CITY OF CODY
PLANNING, ZONING AND ADJUSTMENT BOARD
TUESDAY OCTOBER 12, 2021
CITY HALL COUNCIL CHAMBERS @ 12:00 NOON

**CITY OF CODY
PLANNING, ZONING AND ADJUSTMENT BOARD
STAFF REPORT**

MEETING DATE:	OCTOBER 12, 2021	TYPE OF ACTION NEEDED	
AGENDA ITEM:		P&Z BOARD APPROVAL:	X
SUBJECT:	SITE PLAN REVIEW: POLLEN LANDSCAPES RETAIL LANDSCAPE AND GARDEN CENTER. SPR 2021-26	RECOMMENDATION TO COUNCIL:	
PREPARED BY:	TODD STOWELL, CITY PLANNER	DISCUSSION ONLY:

MEETING DATE:	OCTOBER 12, 2021	TYPE OF ACTION NEEDED	
AGENDA ITEM:		P&Z BOARD APPROVAL:	
SUBJECT:	FINAL PLAT FOR THE BROMLEY MINOR SUBDIVISION—A 4-LOT SUBDIVISION. SUB 2021-01	RECOMMENDATION TO COUNCIL:	X
PREPARED BY:	TODD STOWELL, CITY PLANNER	DISCUSSION ONLY:

PROJECT:
ROCKY MOUNTAIN GRANITE
TITLE:
PROPOSED SITE PLAN

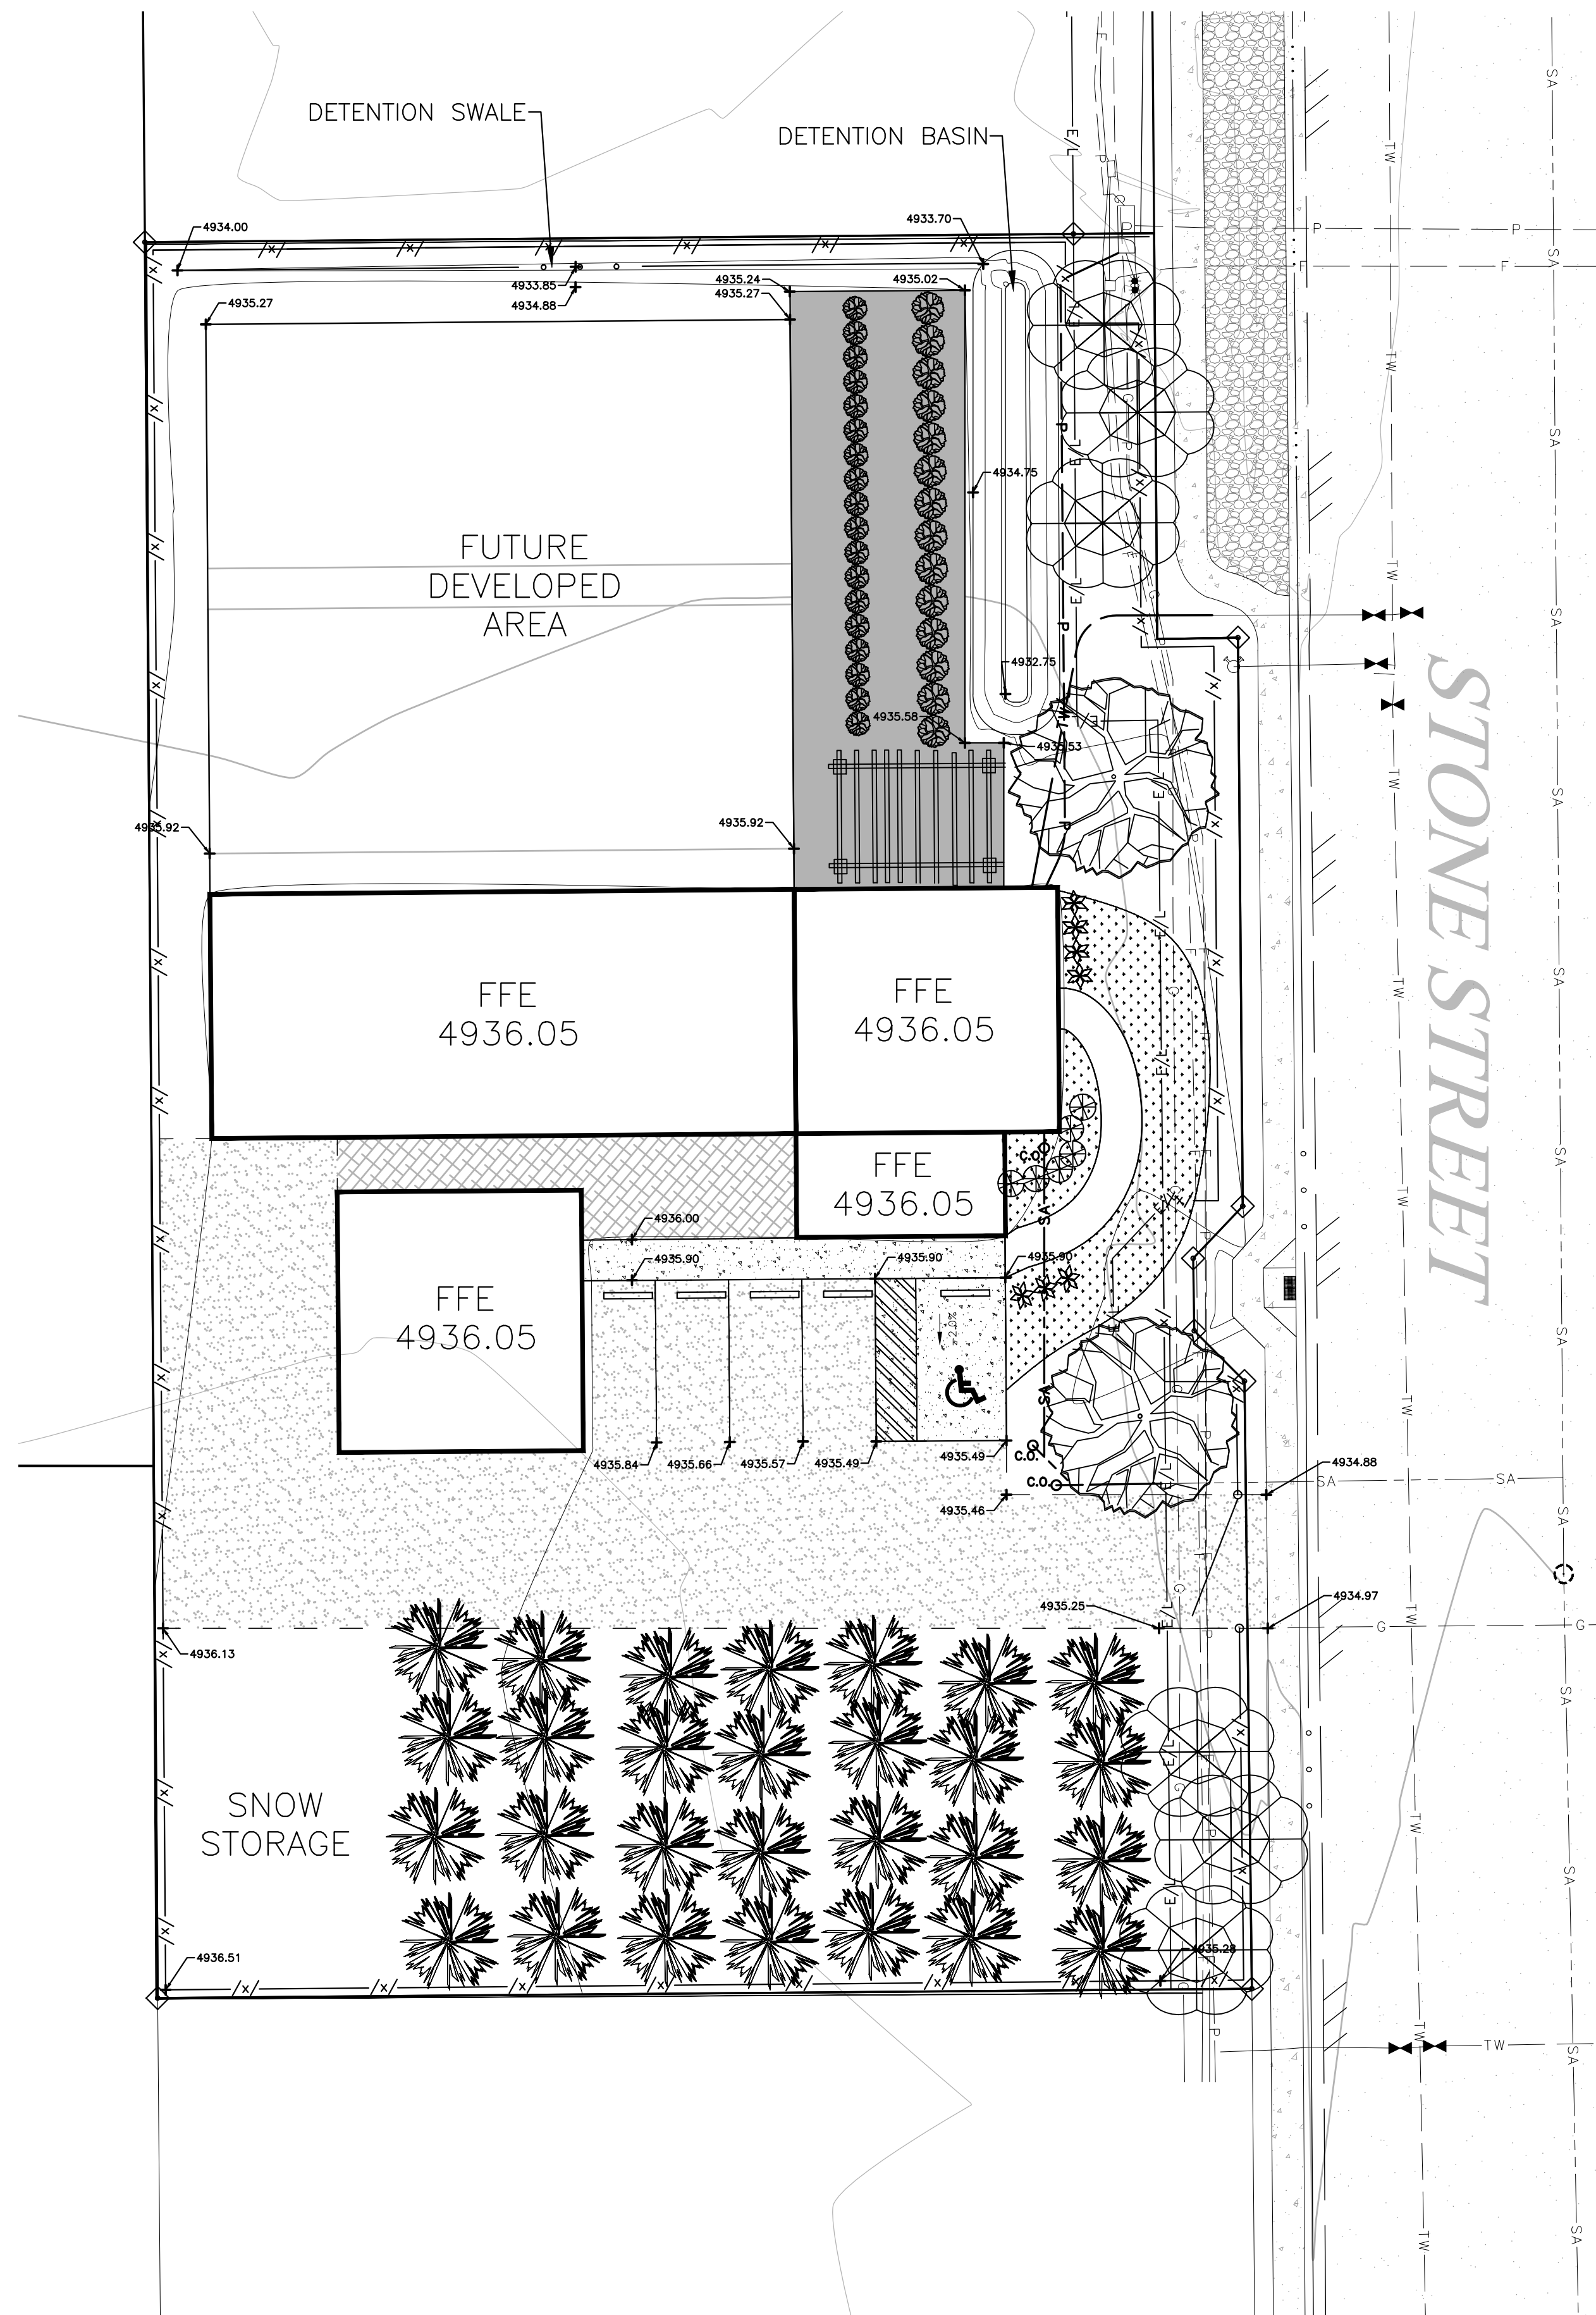
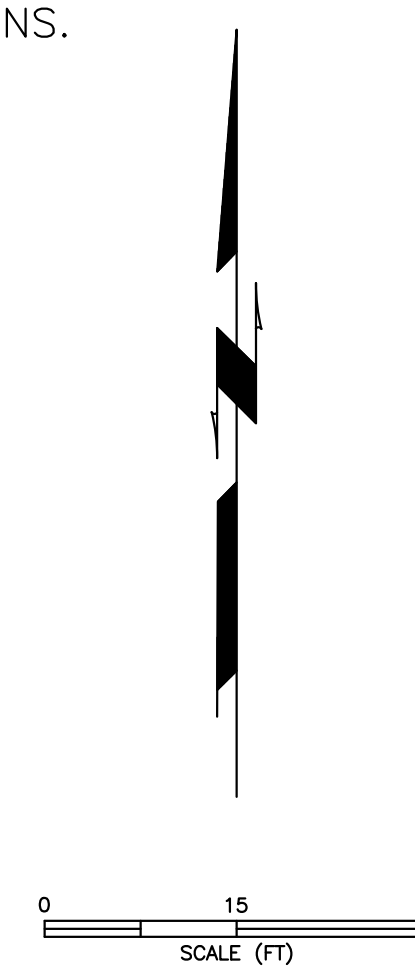
The landscaping plan does need modified to move the trees along the frontage to outside of the 10-foot utility easement (trunks and root balls). The three trees on the north end can be planted in the detention basin, so long as the minimum capacity of the basin is maintained. Alternatively, the basin can be shifted west.

Due to the underground utilities along the front of the property, the fence will need to consider required separation from the utilities, while remaining within the property. The property boundary is about two feet behind the sidewalk. It looks like placing the fence typically three feet behind the sidewalk is the best location to avoid utilities. A minimum 10' by 10' area in the northeast corner will not be fenced in order to provide clearances around utilities in that area. In addition, the fence location should not interfere with the operation of the fire hydrant—the fire code requires 3 feet of clearance. The fire hydrant location, combined with the existing utilities cutting close to

the property corner at that same jog may mean shifting that jog in the fence a few feet to the south.

That being said, if it were my project, I would elevate the retail building at least another six inches. Two reasons. It would provide better drainage away from the building (currently, there is almost no slope away from the south side of the building) and the northeast corner of the property corresponds to the low spot in Stone Street--if there were ever a major storm event, the water in Stone Street could pond and be subject to wave action as vehicles passed through the low-lying area. The wave action is the concern. The higher floor elevation would still allow ADA slopes to be met on the entry sidewalk—all benefits with apparently no drawbacks.

The connections for sewer, water, and power are shown appropriately on the site plan. For the water connection, there will need to be a tap made to the existing 4" line that is stubbed into the property. Coordinate with Public Works. Applicable utility fees will need to be paid with the building permit.

1. Modify the tree locations so that no trees are planted in the utility easement.
2. The fence may be within the utility easement subject to the following:
The front fence shall typically be installed three feet behind the sidewalk, except no fencing shall be within the north 10 feet of the utility easement and at least three feet of clearance must be provided around the fire hydrant.

4. Pay the applicable connection utility fees with the building permit fees. Coordinate installation with Public Works. As shown, all utility services are to be installed to run directly across the utility easement before running north or south to the building.

5. To meet the residential fencing/buffer requirement, provide the 6-foot privacy fence along at least the south 65.8 feet of the west property line and plant dryland grass or other landscaping in the 15-foot buffer area (snow storage area).

BROMLEY MINOR SUBDIVISION

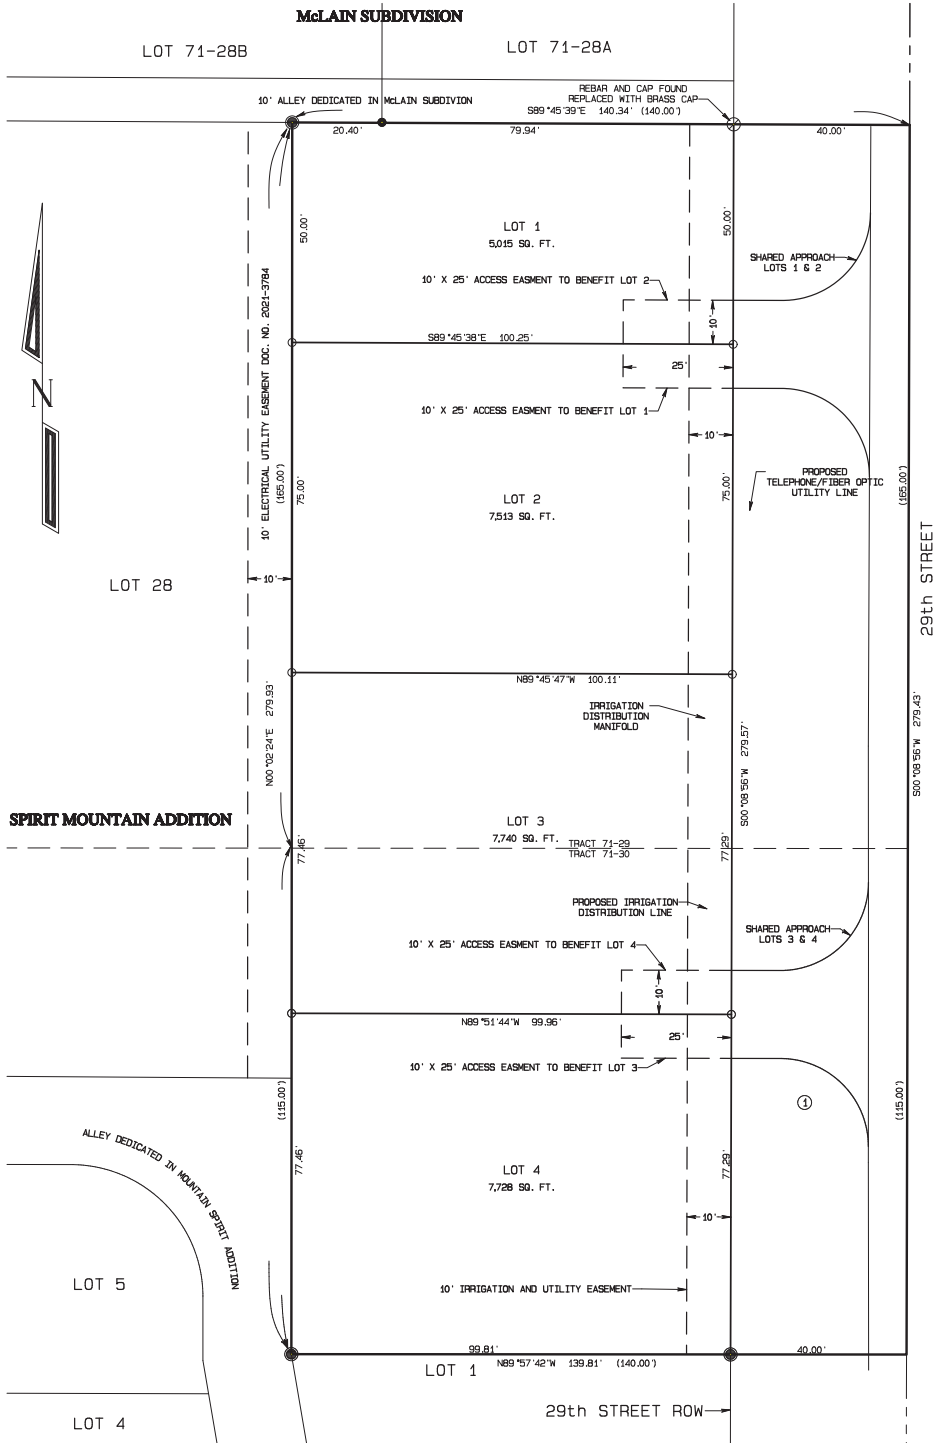
1. Applicable water tap fees and the estimate for the electrical materials have been paid.
2. The final plat has a few typos and extra labels/language that need deleted.

3. The preliminary plat process did not clearly address the timing of removing the utility lines that currently cross Lot 1 and serve the house on Lot 2. The plan is to remove those lines, so that associated easements do not need to be established for them, which easements would severely restrict the buildable area on Lot 1. Each of these existing utility lines need to be removed prior to the final plat being recorded. They will be replaced with services from the new line along the west side of the property. Therefore, new electric, cable and telecommunication lines need to be installed along the west side of the property and connected to the house on Lot 2, and the existing power, cable and telecommunication lines crossing Lot 1 need to be removed prior to the final plat being recorded.

- c. Contribute \$11,200 to the City of Cody for use towards installation of the pathway along the subdivision frontage.
 - d. New electric, cable and telecommunication lines need to be installed in the easement along the west side of the property and connected to the house on Lot 2; and the existing power, cable and telecommunication lines crossing Lot 1 to Lot 2 need to be removed.

- e. Coordinate with the electric division on the removal of the yard light and pole in conjunction with installation of the new electrical lines along the west side of the property.
 - f. Correct the typos and remove the extra labels/language from the final plat.
Coordinate with the city planner.
- 4. The irrigation distribution system must be installed per the approved plan prior to issuance of any building permits.
 - 5. The sewer and water services must be installed to each lot per the utility plan prior to issuance of any building permit for the lot served.
